**RE: RE: 6/2021/3422/MAJ - Salisbury Square, Hatfield, AL9 5AD**

We are aware that Hertfordshire County Council, as the Lead Local Flood Authority (LLFA), issued an additional holding objection to the Planning Application for 6/2021/3422/MAJ – Salisbury Square, Hatfield in July 2022.

*“The applicant should address the points raised in the above in the form of a Sustainable Surface Water Management Strategy Compliance Report. This must clearly demonstrate how the proposal is aligned with Local and National Standards, CIRIA C753 and Local Policy” (LLFA Response: July 2022)*

**Figure 3 – Surface Water Flood Risk Maps**

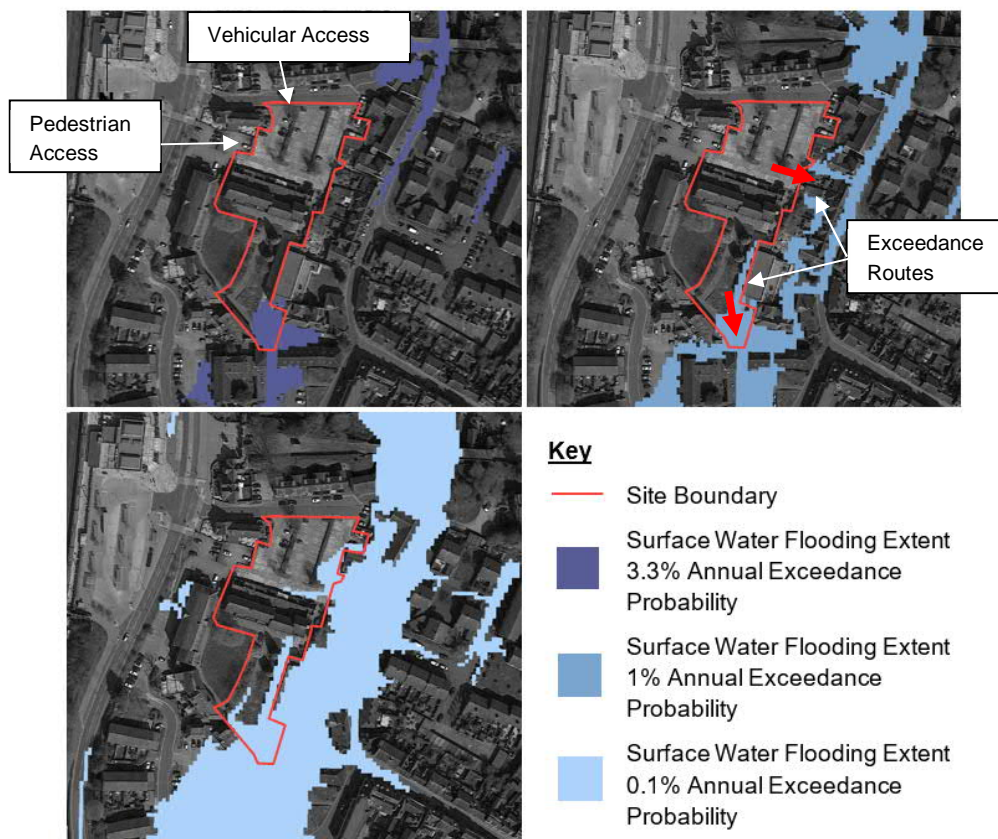
5) As previously highlighted to the applicant the site is deemed to be at low, medium and high risk of surface water flooding. We require further clarification establishing the location/extent of any existing and potential surface water flood risk alongside surface water flood maps. In areas where flooding from surface water is identified, we require clarification on the mitigation methods

used to overcome this to ensure there is no increase in flooding both on and off site from the proposed development. Pre and post development mitigated surface water flow paths should be identified on plan, this should include explanation of safe ingress/egress in times of exceedance.

As per surface water flood risk mapping (figure 3, below) safe access/egress of the site will be possible through the identified vehicular access in the north-western corner of the site from Arm and Sword Lane and pedestrian access from the A1000 on the western side of the site in all return period events up to the 1 in 1000 year return period. No significant re-profiling of the site is proposed, and the proposed drainage strategy captures and attenuates flows – therefore betterment is anticipated over the scenarios shown in these flood risk maps. We have included arrows on the drainage strategy drawing (enclosed) indicating exceedance flow routes in flooding scenarios, flows from catchment 2 are directed to a localised low spot in the south of the site adjacent to a pedestrian access to Park Street and for catchment 1 the additional pedestrian access through to Park Street on the eastern side of site respectively.

Comparing the extents shown to the surveyed topography of the site gives the following approximate flood levels represented on the site;

Annual Exceedance Probability	Approximate Maximum Flood level (mAOD) Catchment 1	Approximate Maximum Flood level (mAOD) Catchment 2
3.3%	n/a	72.2
1%	71.1	72.5
0.1%	71.8	72.9

Finished Floor Levels (FFLs) will be set a minimum of 150mm above the maximum surface water flood level of 72.9mAOD. The topographical survey has been enclosed.
